**CITY OF BOULDER**  
**AGENDA ITEM PLANNING BOARD**  
**MEETING DATE: June 4, 2015**

Public hearing and Concept Plan Review of a proposal for the expansion and renovation of an existing automobile sales and service facility at 2465 48<sup>th</sup> Court (Larry H. Miller Toyota). Proposal includes various site improvements and an approximately 28,500 square foot addition to the north (rear) side of the building, which requires merging the two existing parcels.

**Project Name:** Larry H. Miller Toyota Expansion

**Location:** 2465 48<sup>th</sup> Court

**Figure 7: Site Plan**

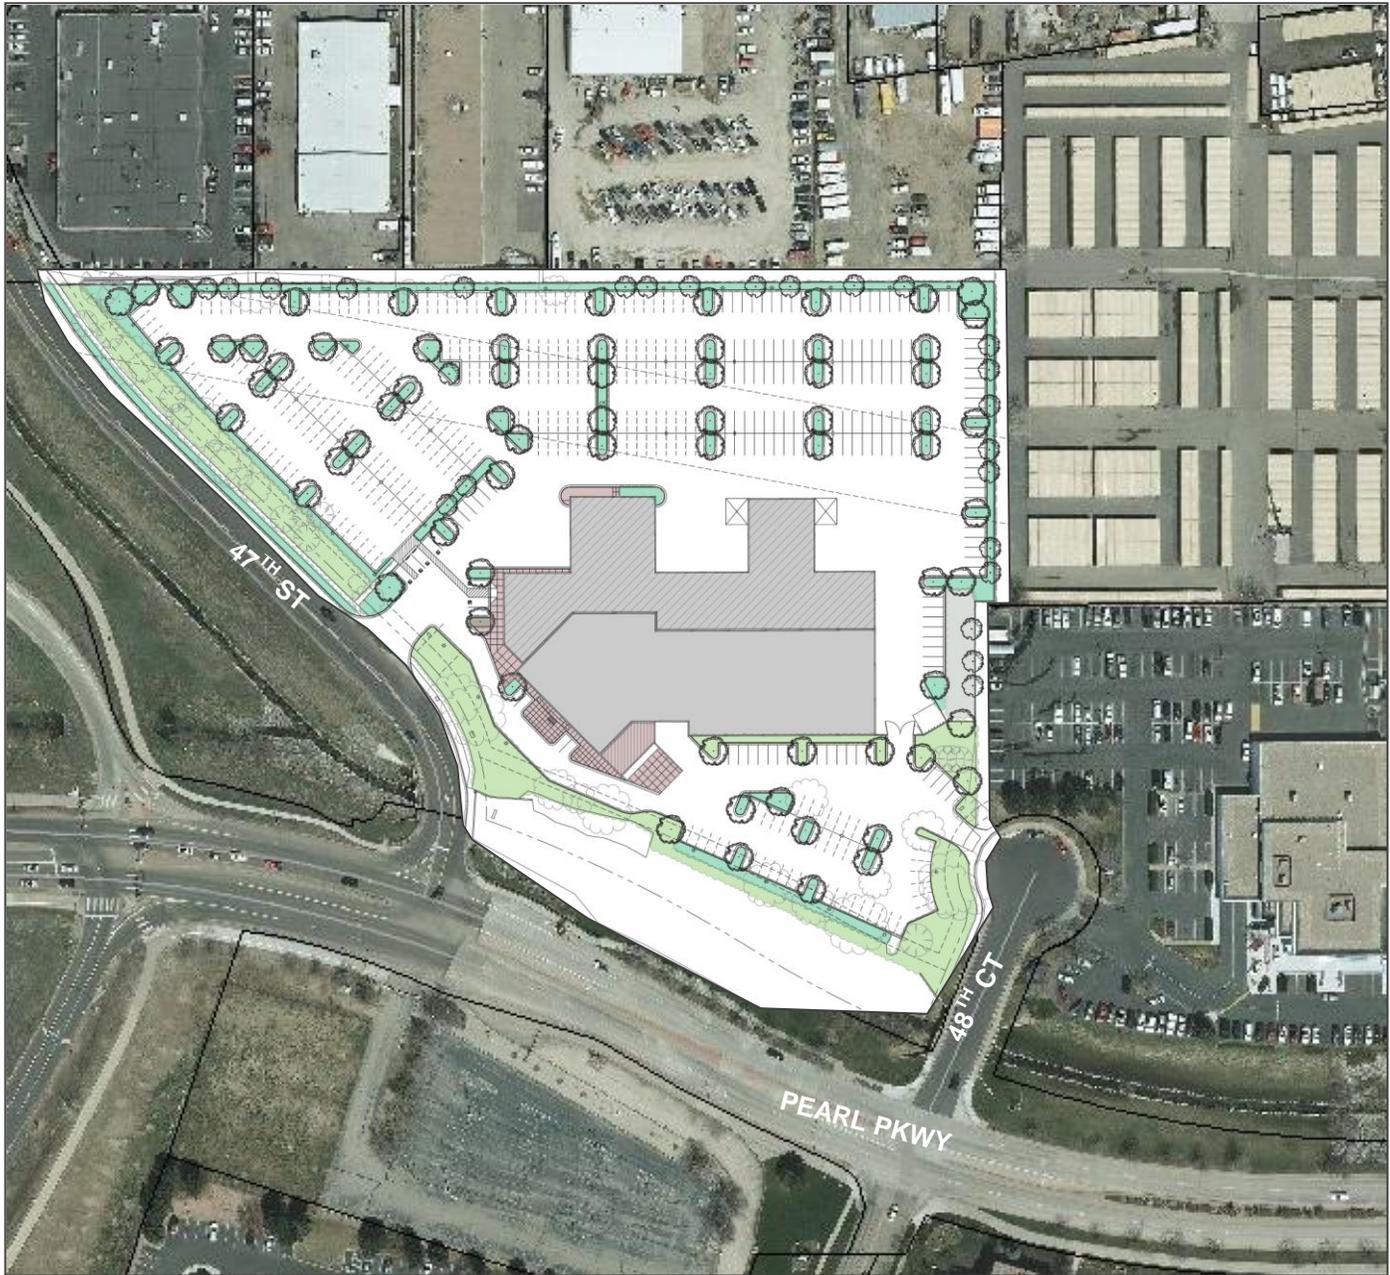
As shown in *Figure 7* below, the general site layout will be unchanged. The majority of the site will continue to be used for vehicular display and storage. However, as part of redevelopment the parking areas will be re-constructed in order to meet the city's landscaping and outdoor lighting standards. The proposal includes landscape screening of the vehicle parking lot from the street and adjacent properties and parking lot landscaping islands that will support large trees. The existing lighting fixtures will also be replaced to meet the city's dark sky ordinance and outdoor lighting code.

The proposal includes the relocation of the main access and curb cut on 47<sup>th</sup> Street to reduce the congestion that currently occurs as cars turn from Pearl Parkway onto 47<sup>th</sup> Street. The access would be relocated to the northwest by approximately 45 feet and expanded to 40 feet in width (refer to *Figure 9* below). Staff is in support of shifting the existing drive entry on 47<sup>th</sup> Street away from the intersection however, the curb cut may not be larger than 35-feet in width per the City of Boulder Design and Construction Standards (DCS). This detail will be required to be addressed at the time of Site Review. There is

currently no pedestrian access along 47th Street from Pearl Parkway to Pearl Street to the north. The proposal includes the construction of a 5-foot sidewalk and 8-foot tree lawn along this frontage (see *Figure 8*). Staff will also likely require a detached 5-foot sidewalk along the property's frontage with the 48th Street Court at time of Site Review.
